RE: 202 E Washington, Ann Arbor, Michigan

I met with you and several others earlier this week at 202 E Washington, Ann Arbor, Michigan. Concerns had been expressed about the structural integrity of the main floor window frames.

TYPICAL CROSS SECTION THRU BASEMENT WINDOWS

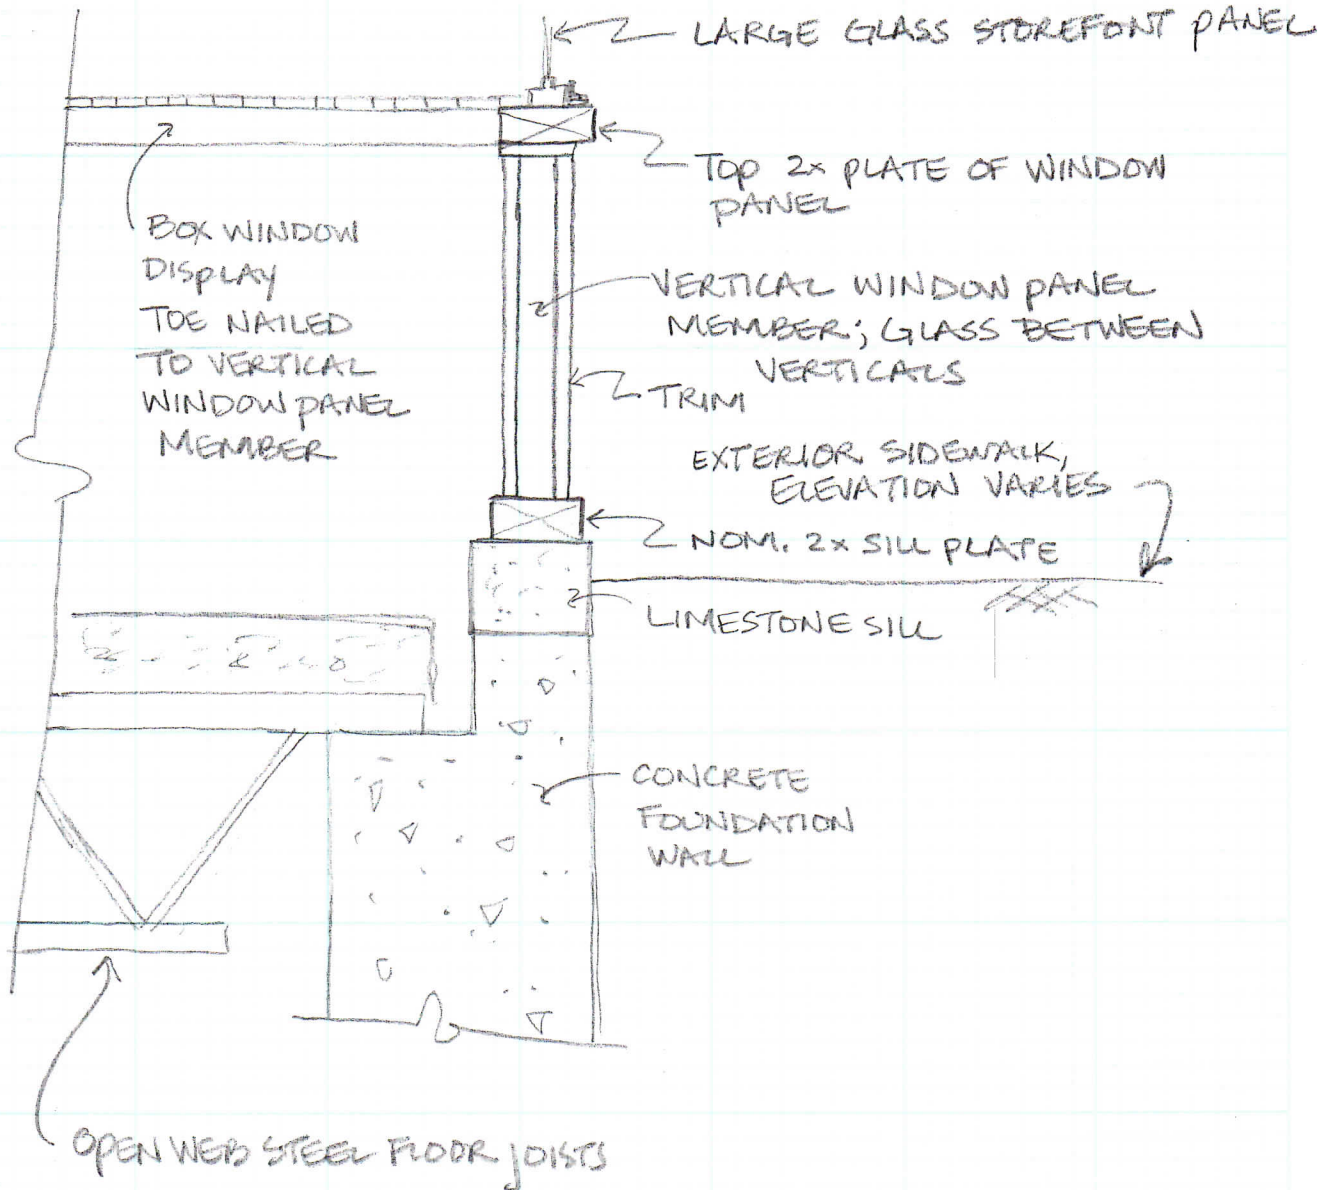
Along the north side of the building, the bottom members (the nom. 2x sill plate) of the wood framing below the large storefront glass panels has shifted outward toward the street significantly. Similar movements were observed elsewhere, but not to the extreme condition observed at the western most bay of the north elevation. I have attached a sketch of a cross section through this north wall that describes the existing construction of the windows. Construction along the west wall is similar, but the windows and stone sill are bearing on a steel beam as the basement extends further west below the sidewalk above. The elevation of the exterior sidewalk varies slightly around the perimeter of the building, but is relatively close to the bottom members of the wood window frames (less than 6" at most).

I suspect the nominal 2x sill plates at the bottom of the window framing are deteriorating from their close exposure to grade and thus snow and other moisture sources. The panel with the extreme lean may also be deteriorating due to its proximity to the radiator hidden in the wood display box at this window bay. Unfortunately, direct access to the structural bottom plates of the window framing could not be obtained during my site visit to confirm the deterioration of the wood. When probed from the exterior, there were several locations where a screw driver tip could penetrate the wood sill up to 3/8 of an inch.

The window framing is supported on the nom. 2x sill plate up to the lintel above. The top 2x plate above the smaller basement windows spans between the vertical window panel members that then bear on the nominal 2x sill plates. Should the sill plates fail, the vertical members will settle or shift as well, removing support for the top 2x plate that directly supports the large glass storefront panels.

Regardless, though, rebuilding of the window frames is recommended, especially where the frames have shifted significantly. Considering the proximity to final grade on the exterior, I recommend the frames be rebuilt with treated lumber or other non-deteriorating material. Profiles and sizes of members can be matched to meet any historic district requirements. Use of the treated wood may be problematic if the treated wood is in any contact with any existing steel (at building columns? near joists or beams? fasteners for existing framing?) as the treated wood will corrode the steel. Painting of the treated wood would be required regularly (annually?) as well. Window frames are now available in other materials that may service this area of the building in a more economical manner and still provide the historic profiles desired. I refer you to Quinn Evans Architects and your window supplier to determine the best solution that will fit your needs.
